## Email: Desert Harvest Solar Project EIS

### NOTICE OF AVAILABILITY OF A DRAFT ENVIRONMENTAL IMPACT STATEMENT/ DRAFT CALIFORNIA DESERT CONSERVATION AREA PLAN AMENDMENT FOR THE DESERT HARVEST SOLAR PROJECT, (SCH # 2011094004), RIVERSIDE COUNTY

The Metropolitan Water District of Southern California's Detailed Comments on the April 2012 Desert Harvest Solar Project Draft EIS and Draft CDCA Plan Amendment

**Figure 1**  
Water Level Data  
In Vicinity of Project

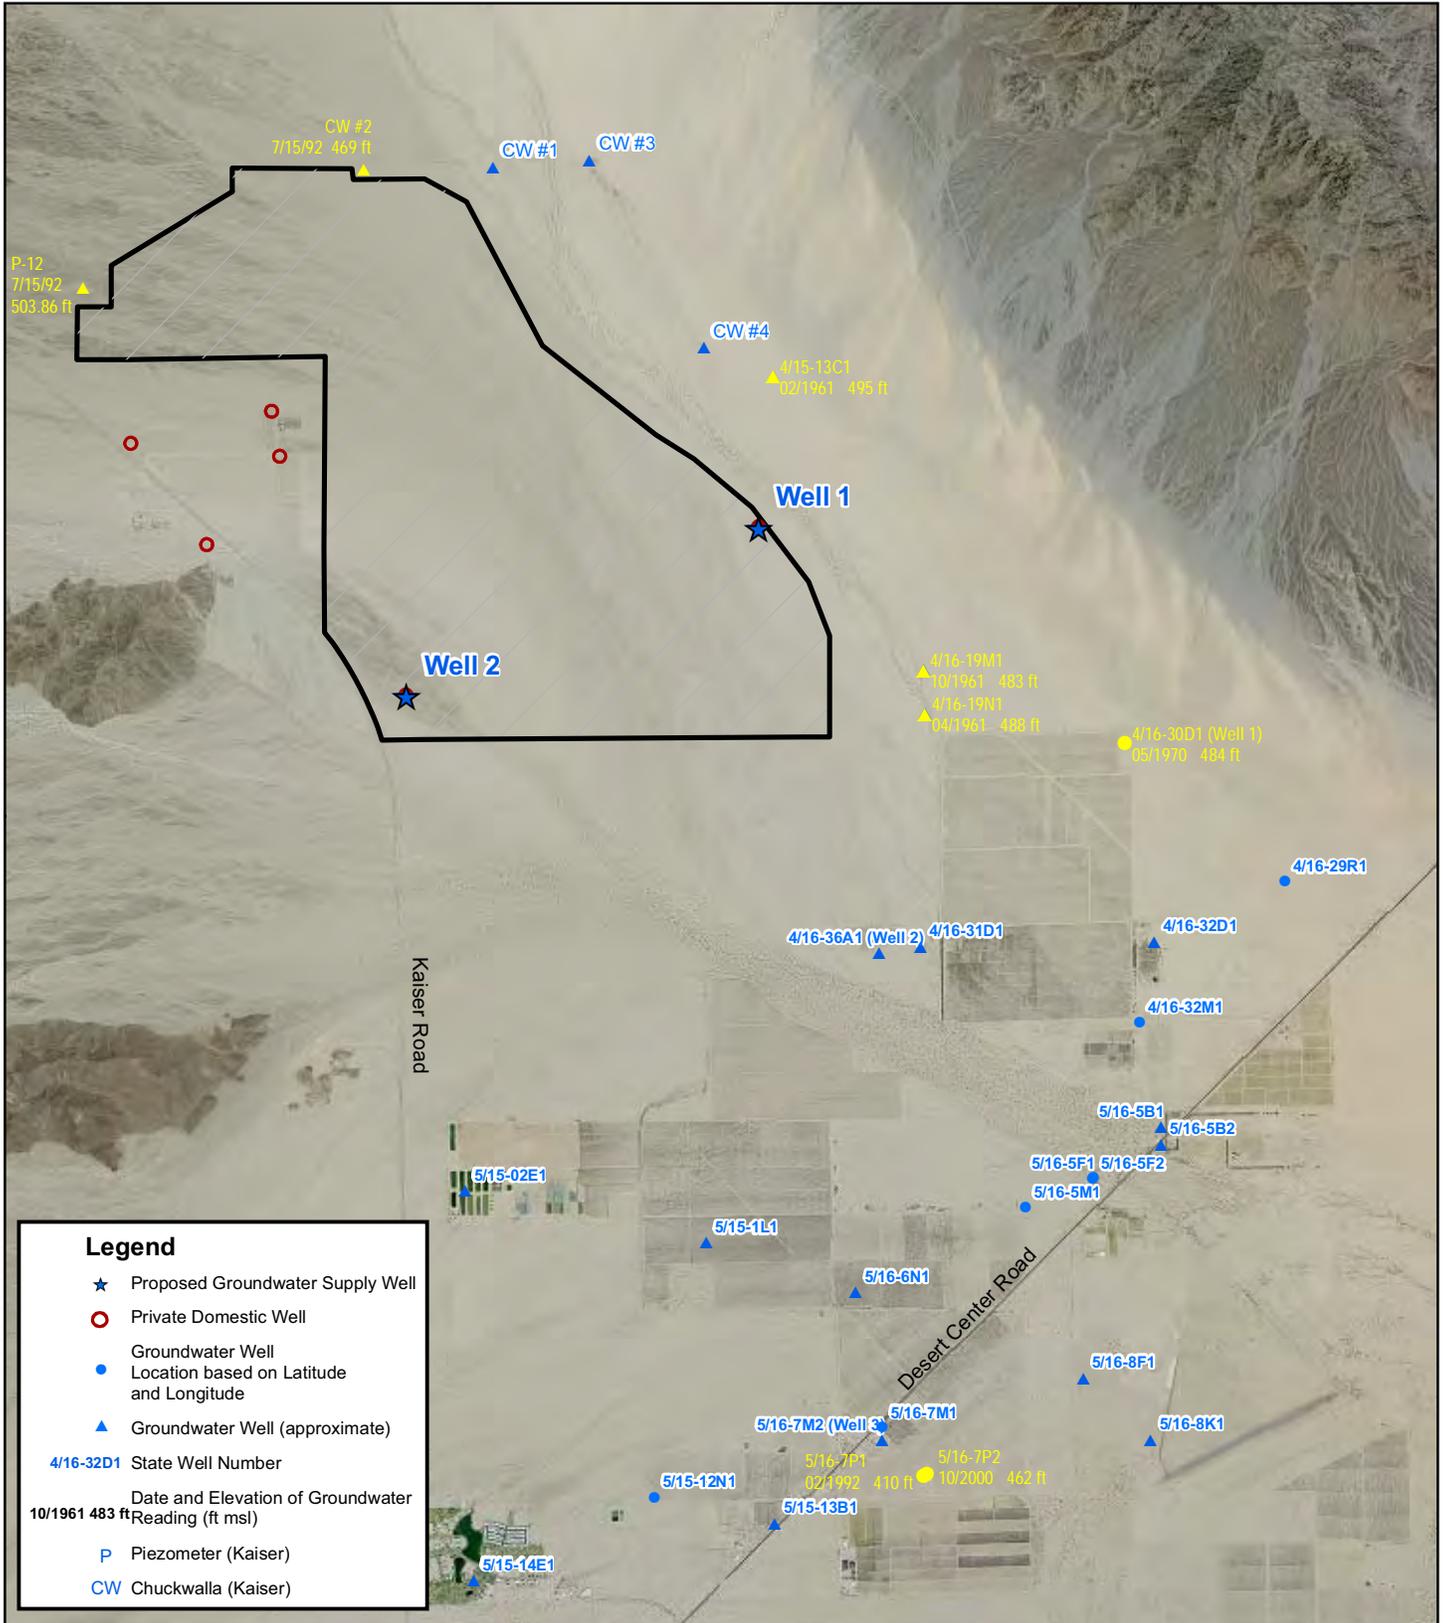
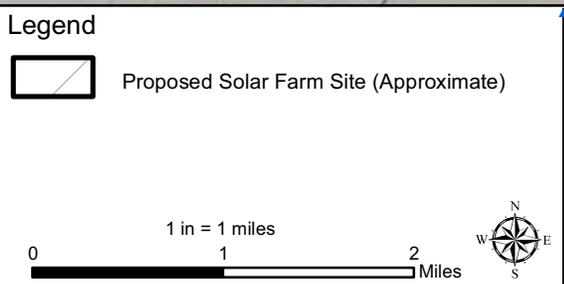
- 6 Values in BOLD, are shown on Figure-1 "Site Plan Showing Recent Water Level Data for Wells Adjacent to the Project Site".
- 7 Proposed Accounting Surface elevation after USGS 2008-5113 (Weile et al, 2008), Figure 6, "Map showing the accouting surface in the Parker, Palo Verde and Cibola Valleys and adjacent tribuary areas in California and Arizona".
